**RHIC Collider Tunnel
Life Safety Analysis**

Re: Change in RHIC Collider Tunnel Fire Protection

Subject: Phenix Collider Hall Dead End Exemption - Building 1008

**TECHNICAL DETAILS
FOR THE EQUIVALENCY REQUEST
FOR DEAD END DISTANCE
ADJACENT TO THE PHENIX COLLIDER HALL
BUILDING 1008**

PHENIX COLLIDER HALL
DEAD END EXEMPTION DETAILS

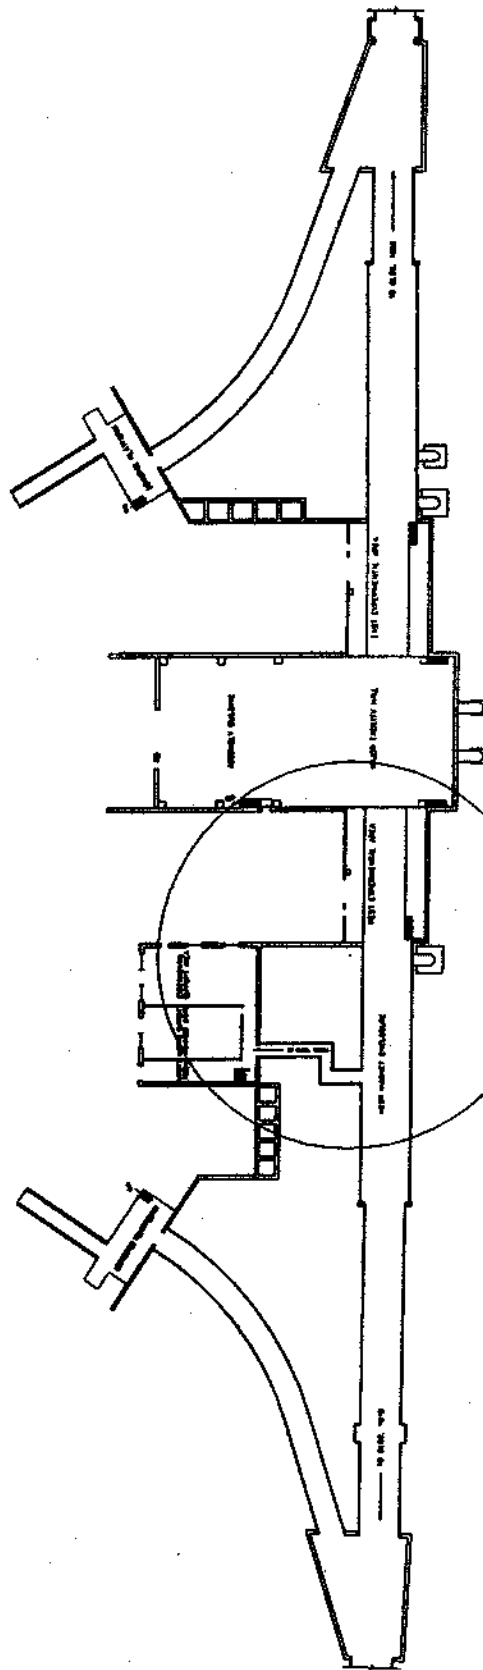
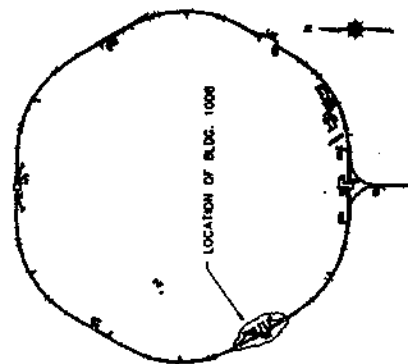
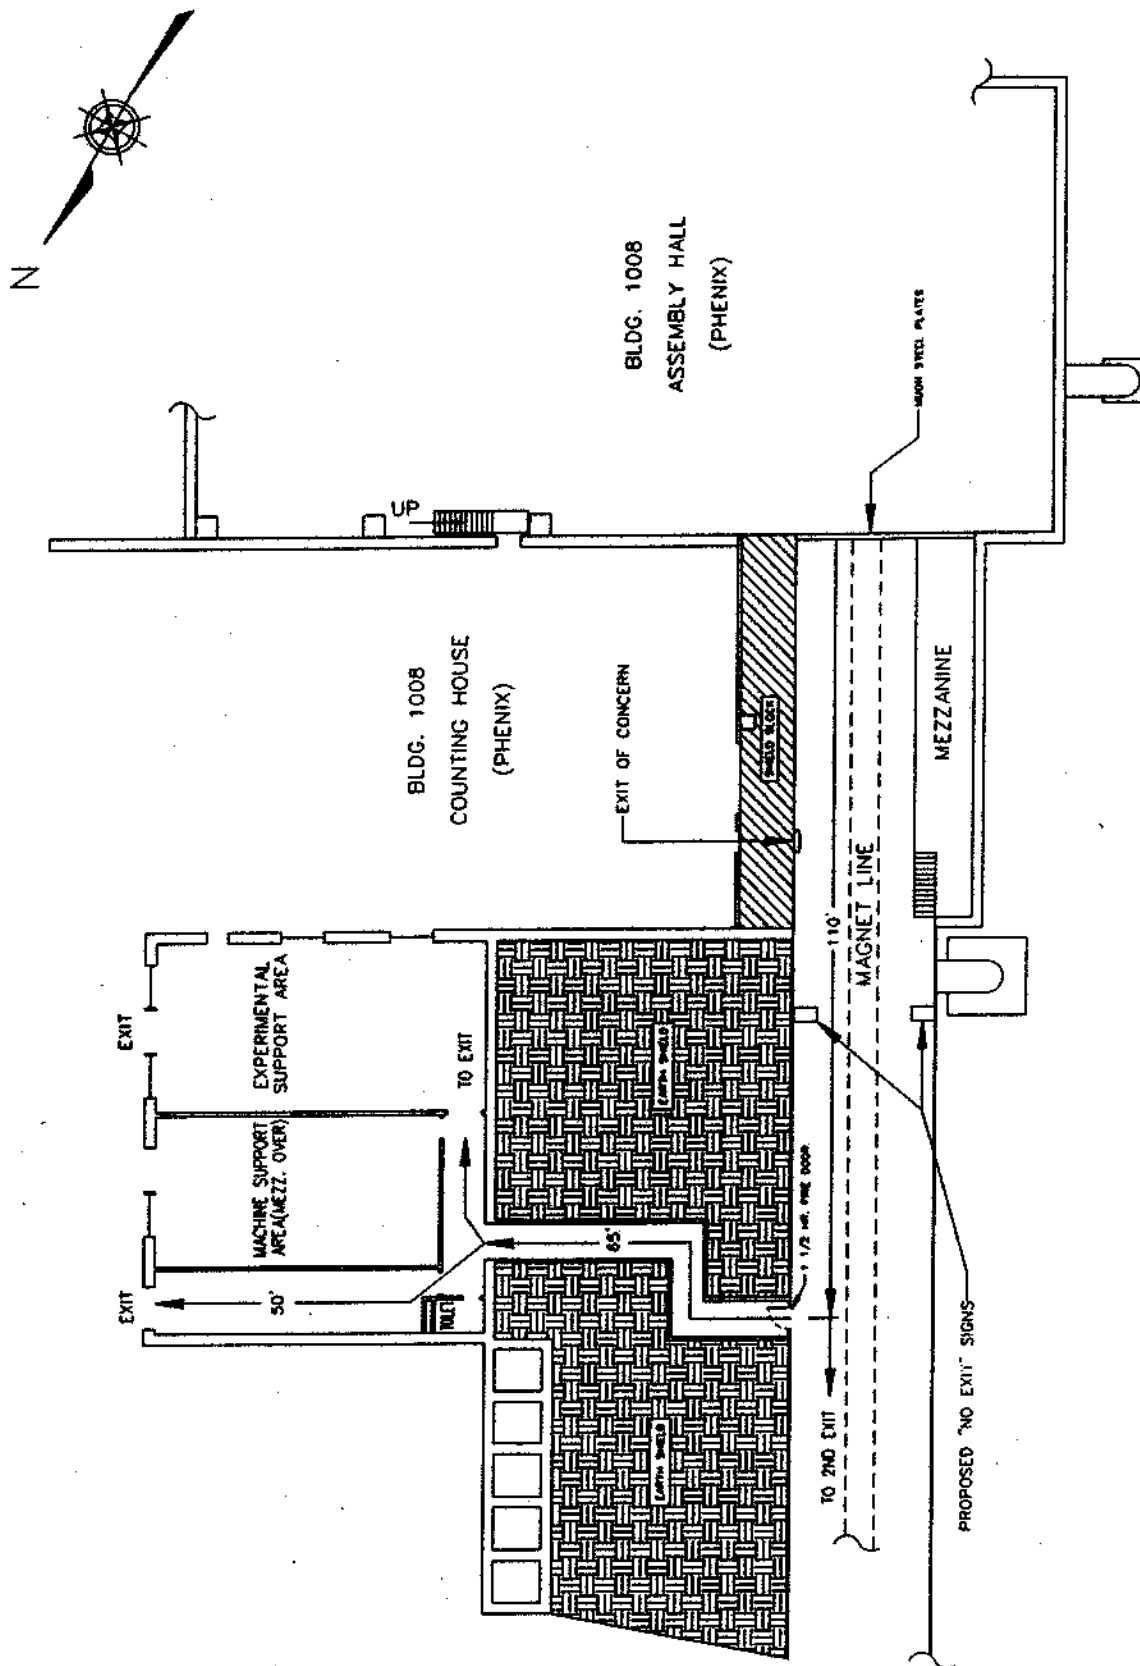
The subject analysis addresses the tunnel segment just north of Building 1008. This segment of tunnel is a one story, underground structure with concrete floors, concrete walls, and a concrete ceiling. A portion of the east wall is an insulated metal panel with exterior shielding block. The southern part of the tunnel is sealed off by steel muon plates that completely cover the tunnel opening. An exit door on the east wall was intended to limit the dead end distance/common path of the tunnel to under 50 feet. When this door is sealed off by the shielding blocks, the dead end distance/common path of travel will become 110 feet.

1. A person in the region of the tunnel will travel approximately 75 feet down the dead end before realizing there is no exit. Approximately 150 feet of extra travel will be incurred.
2. An excessive common path of travel is present.

Dick Diem has it in his hands. We walked the area. He is asking for two items (it is in the nature for people to add their two cents, but in Kick's case it is about \$800).

1) The dead end tunnel section should be illuminated by battery pack emergency lights (as a backup to the emergency generator set, to improve reliability of the lighting).

2) The "No Exit" Signs should be Tritium type (i.e., self illuminating).

1. Posting of "No Exit" signs will warn occupants, who should be relatively familiar with the area, not to travel down the dead end space to seek an exit.
2. Smoke detection will notify occupants in the early stages of the fire development of the need to start evacuation.
3. The smoke removal system, and the inherent low combustibility will limit the fire from endangering an exiting individual.
4. The smoke removal system will minimize the impact of impaired visibility normally encountered by smokey fires.

Enclosed is the referenced memo which approves the equivalency request for the RHIC tunnel dead end adjacent to the Phenix Collider Hall. The mitigating factors as detailed in your request shall be implemented as well as increased emergency lighting and additional signs in the dead end area. Mr. Joseph Levesque of your staff is aware of these requirements.

The Chicago Operations Office is granting this equivalency from Sections 28-2.5.2 and 28-2.5.3 of the 1994 Edition of the National Fire Protection Association Life Safety Code (NFPA 101). Exceeding the dead end and common path of travel distance of NFPA 101 is acceptable because of the following mitigating factors; limited number of employees with access to the area, their familiarity with the area, additional signs, increased emergency lighting, limited combustible materials in the area, smoke detection for early warning, and a smoke removal system. These factors will allow the employees to exit safely during an emergency.
